**IN THE MATTER OF AN APPLICATION BY NATIONAL GRID
ELECTRICITY TRANSMISSION FOR AN ORDER GRANTING
DEVELOPMENT CONSENT FOR THE NORWICH TO TILBURY PROJECT**

PINS REF: EN020027

Deadline 2 (12th March 2026)

Comments on Behalf of

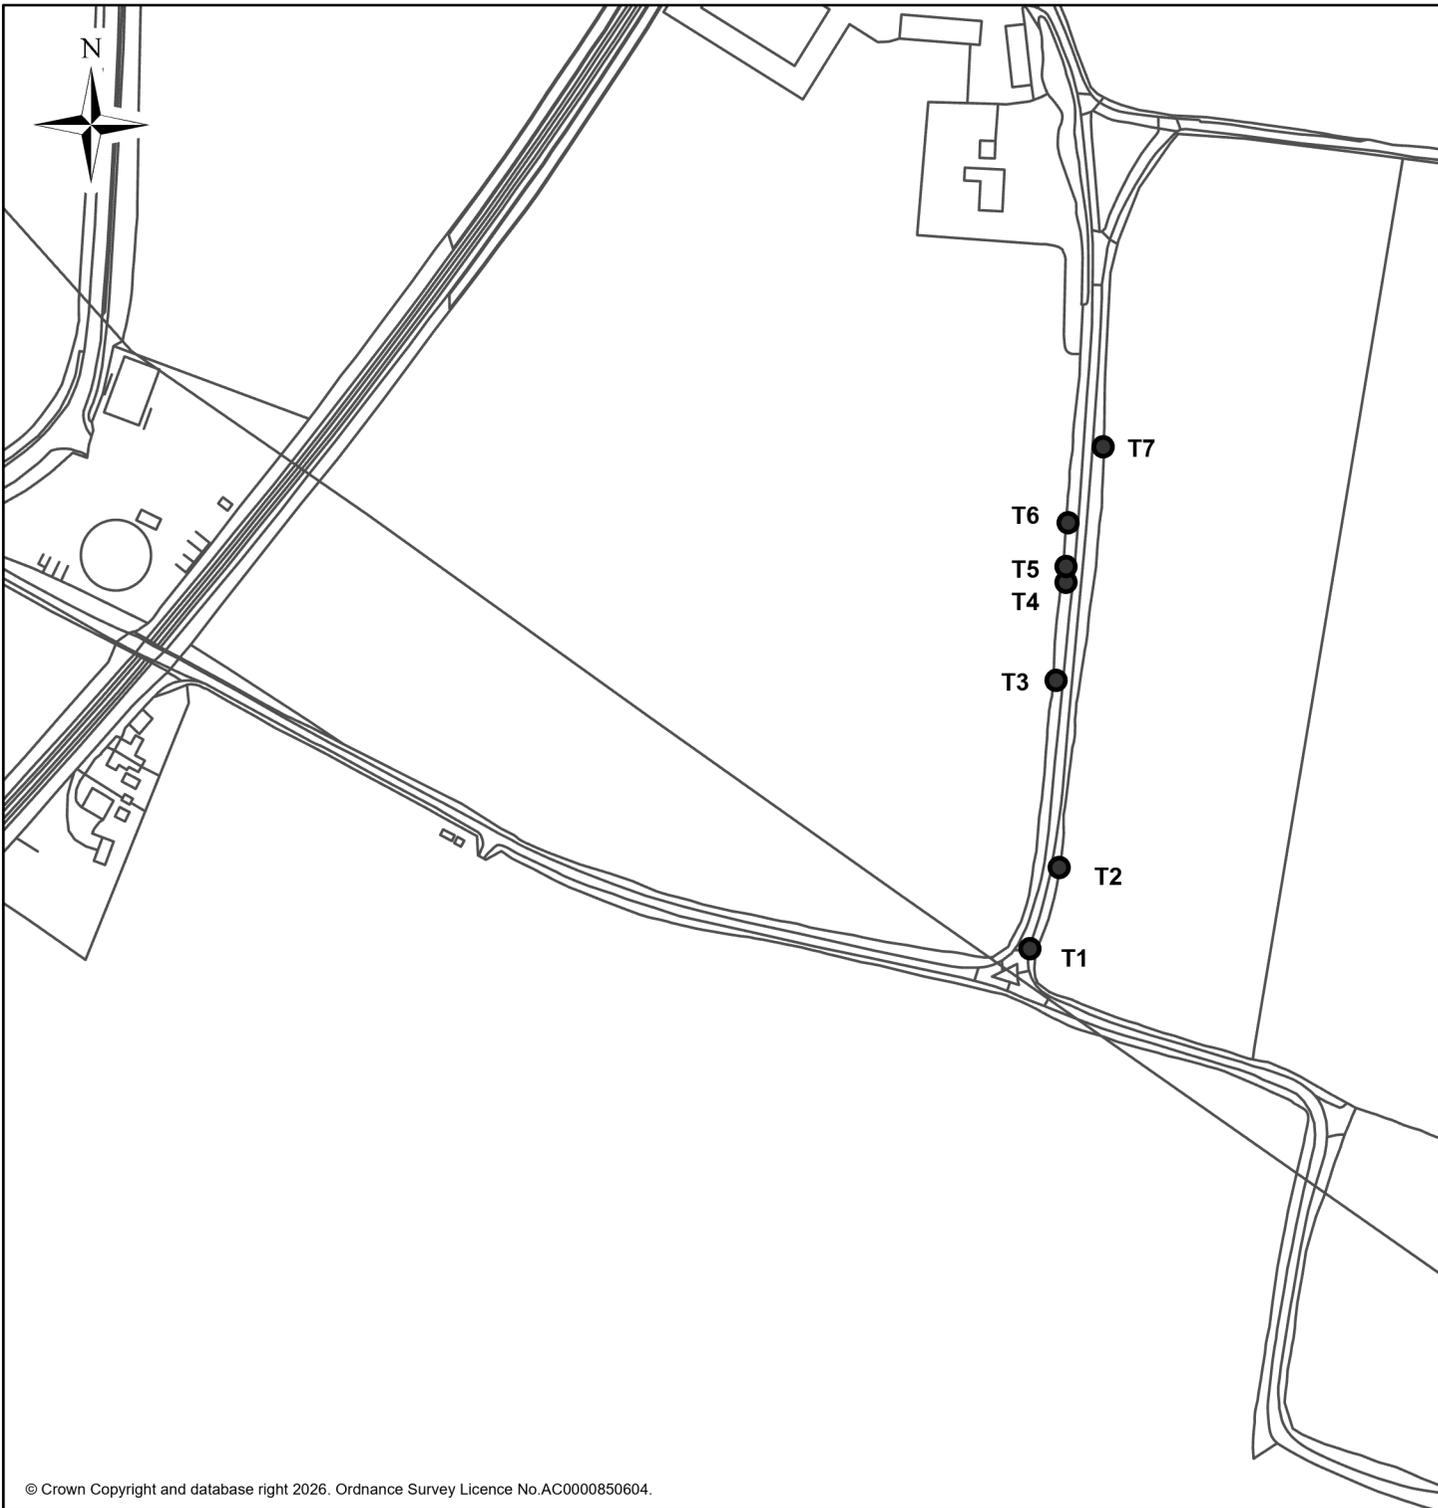
29. These TPOs seek to protect a number of mature oak trees (and in effect associated landscape features) located within areas potentially affected by the proposed development, including locations in the vicinity of Dead Lane and Wick Lane within the ALBA

30. Plans identifying the location of the relevant Tree Preservation Orders are appended to this submission.
31. The Parish Councils invite the ExA to request that the Applicant to confirm whether these recently designated Tree Preservation Orders (26/00001/TPO, 26/00002/TPO and 26/00003/TPO) have now been taken into account and how they are to be addressed through the proposed development..
32. The Parish Councils further note that a number of TPO trees were not identified in the Applicant's arboricultural and landscape assessments.
